BULLETIN NO.
91-029

Gap Between Dashboard and Lower Dashboard Cover

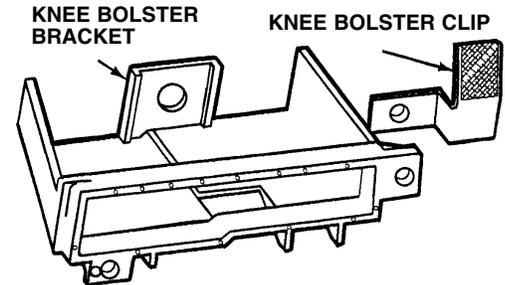
The lower dashboard cover does not fit snugly against the dashboard, leaving a gap.

2. Remove the three lower dashboard cover mounting screws, then remove the cover.

3. Install the knee bolster clip under the right knee bolster bracket mounting screw.

4. Make sure the ignition switch grommet is positioned correctly, then insert the lower dashboard cover's upper right mounting clip into the slot in the dashboard.
5. Install all three cover screws finger-tight. While pushing the cover up and forward, tighten the upper left screw first, followed by the lower left screw, then the lower right screw.
6. Reinstall the courtesy light controller (LS) or the plastic cover (STD, L). On LS models, turn on the headlights and make sure the courtesy light controller works properly.
